**AIRBUS ANSWER**

**Accident/Incident:** NLG Collapse after push back - LXR MSN 221

**Airbus Answer to Safety Recommendation Ref:** 01

**From Report Ref:** 01/INCID/2004

Figure A-USUXX - Sheet 01  
- Selector Manifold Assembly

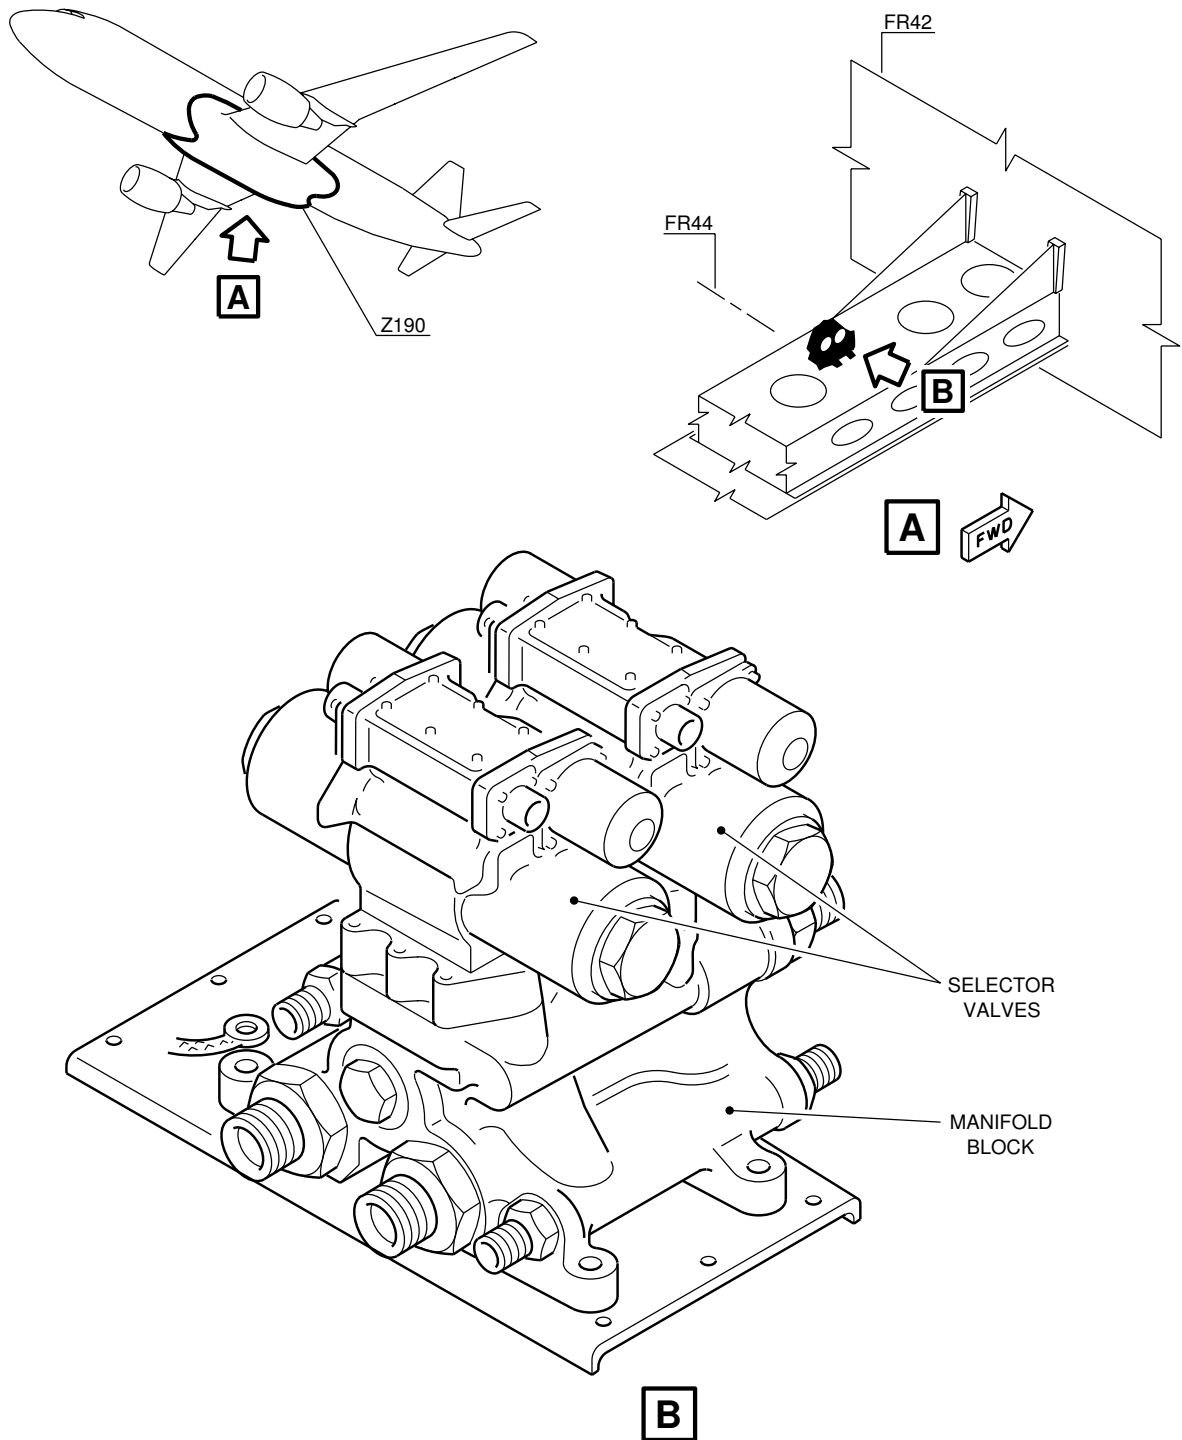
This Service Bulletin introduces GE Aviation Service Bulletin No. 200-32-535. This GE Aviation Service Bulletin introduces new CX seals which are more reliable and less prone to damage.

The mandatory Inspection Service Bulletin A320-32-1290, for the gear and door selector valve inspection, will not be required if both of the valves have been modified on the selector manifold assembly. The Inspection Service Bulletin A320-32-1290 will be applicable if a Pre-Modification valve is fitted to a Post-modification selector manifold assembly.
